Introduction

This Customer Notice provides detail further to Customer Notices LLWR-CN-2015-20 and LLWR-CN-2015-22, which were issued regarding the risk of water ingress to TC01, TC03 and TC08 containers.

Figure 1: Breathable Gasket (Correct Orientation)

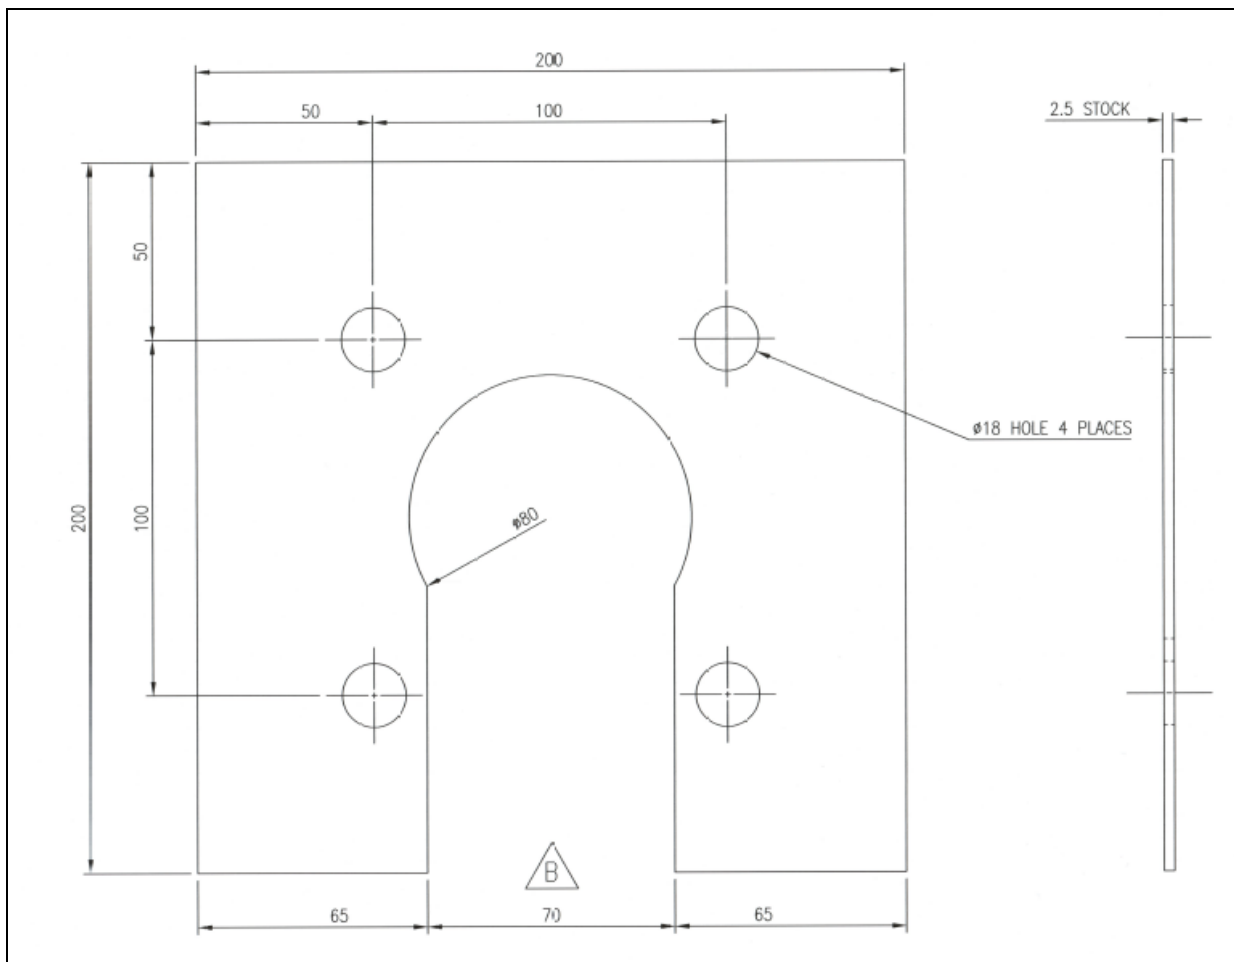
This Customer Notice is directed to customers who currently own or are in custody of affected IP-2 ISO TC01, IP-2 ISO TC03, or IP-2 ISO TC08 designs (see referenced Customer Notices for detail of affected containers). It communicates the requirements and method for fitting breathable gaskets (see Figure 1) to the aforementioned containers in order to mitigate against potential water ingress.

The breathable gaskets are manufactured from bright yellow PVC so as to distinguish them from the vent port gaskets.

NOTE: To source a replacement vent port gasket for TC01s, TC03s, and TC08s, please contact the LLWR Transport and Logistics team at transportandlogistics@llwrsite.com.
6. Locate the breathable gasket with the slot opening orientated downwards (as pictured in Figure 1) against the vent port flange so that on a TC01 or TC03 its boltholes align with the vent port flange boltholes, or, on the TC08, it locates on the vent port flange studs.
7. Fit the vent port cover against the breathable gasket and tighten the four fasteners to a torque of 38Nm \pm 2Nm.
